Agenda Item

D2

Request
Alternative Compliance (Section 5.3.2 of the Oceanfront Resort District Form-Based Code)

Location
2613 Atlantic Avenue

Proposed Conceptual Floor Layouts

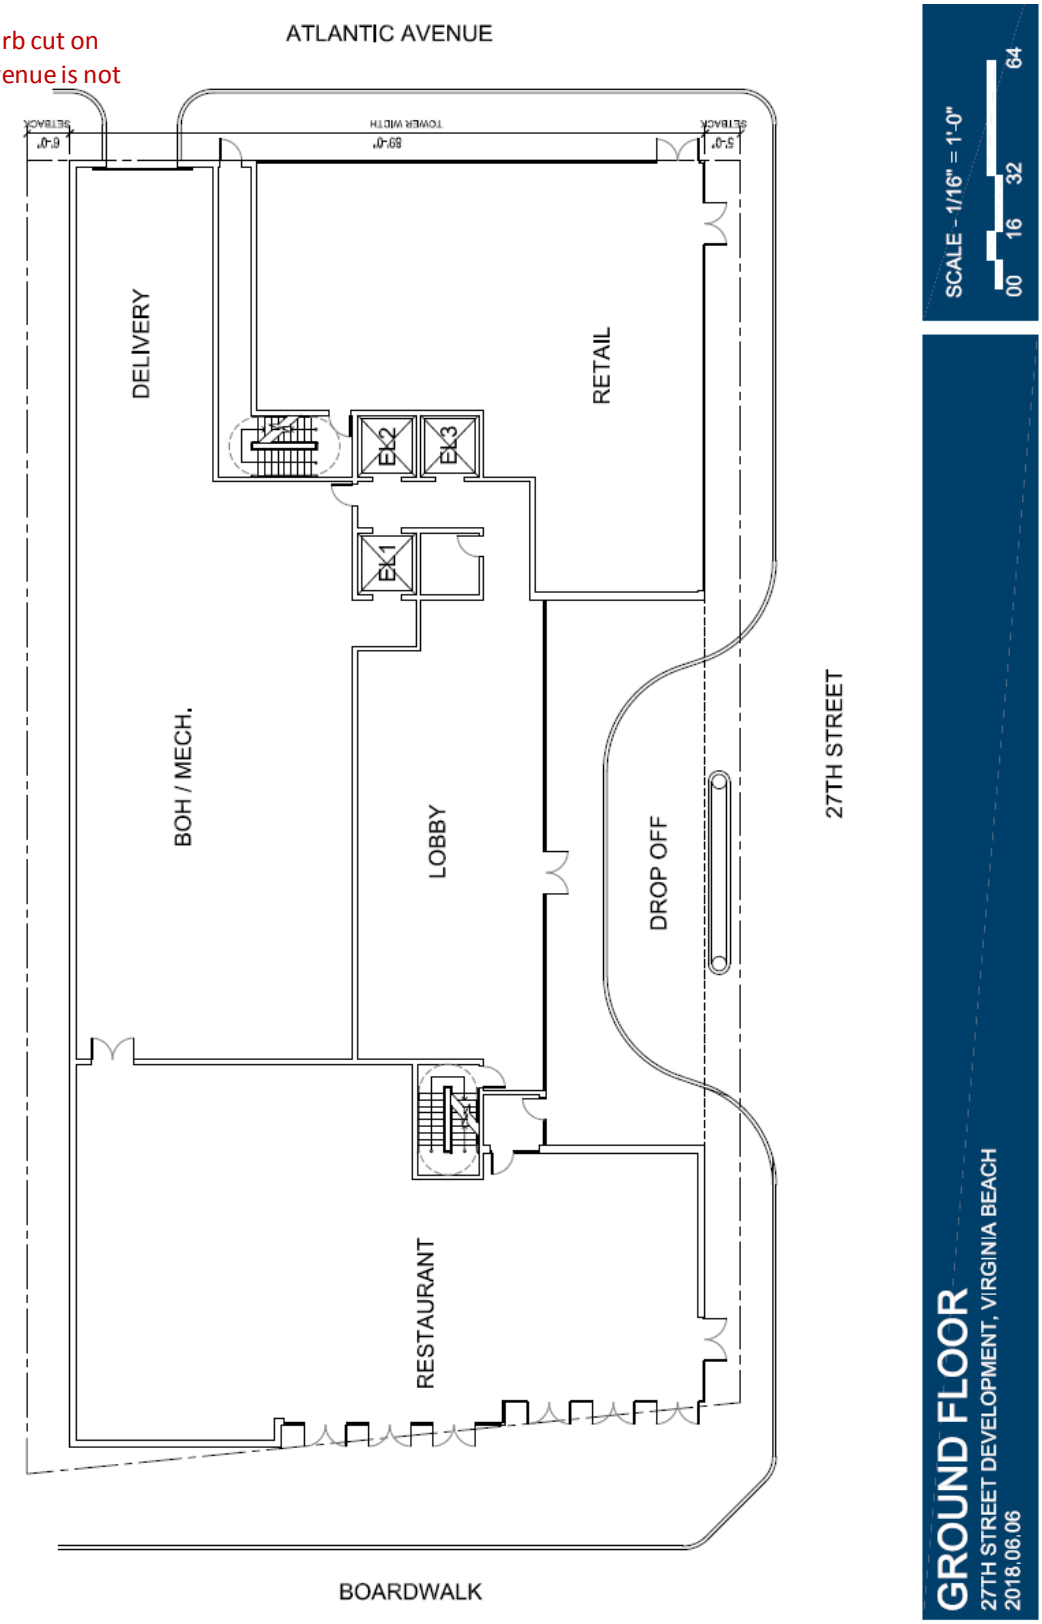
Delivery curb cut on Atlantic Avenue is not approved

Door swings and other encroachments into right-of-way are not approved.

5. Approval of this Alternative Compliance shall not serve as an approval of the conceptually shown Open Air Café located to the east of the site in the greenbelt, encroaching door swings, the southern vehicular curb cut on Atlantic Avenue, or any other type of conceptually shown right-of-way encroachment that does not align with the Oceanfront Resort District Design Guidelines. The Open Air Café shall still be required to follow all review policies established by the Resort Management Office and is subject to City Council approval of a franchise agreement.
